August 8, 2017

Thank you for your July 17, 2017 letter on the Budd Inlet TMDL and your interest in the effort to improve water quality in Budd Inlet. I encourage you to attend the Deschutes Advisory Group (DAG) meetings to receive updates on the TMDL. Many of the topics and questions you included in your letter have already been discussed in the DAG meetings. This group provides a venue to ask and answer questions and is an effective opportunity for stakeholders to engage in the process.

Attachment A: Map of aggregated model grid cells and Water Quality Standards in Budd Inlet.

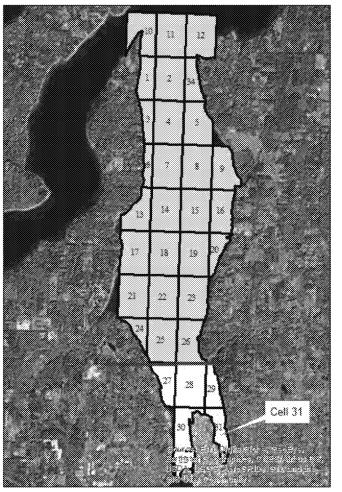
- First, cell 31 (please see attachment A for a map with labeled cells) is no different than other cells *except* in the fact that our model shows it has the lowest dissolved oxygen (DO) concentration in Budd Inlet. DO varies throughout Budd Inlet and we need to meet the standards throughout the Inlet. To meet standards throughout the Inlet we need to ensure we include in our analysis the area where DO is lowest.

- The water quality standards in <u>WAC 173-201A-210(1)(d)</u> establish two relevant numeric criteria for Budd Inlet of 6.0 mg/L and 5.0 mg/L. The boundary between the 6.0 and 5.0 mg/L standard is located near Priest Point Park and has not been changed. Specifically, as listed in the water quality standards in <u>WAC 173-201A-612</u>, it is at 47°04' N. Since this division crosses through the northern portion of cells 27, 28, and 29, we chose to include all of these cells in the 5.0 mg/L category (see red line in attachment A).
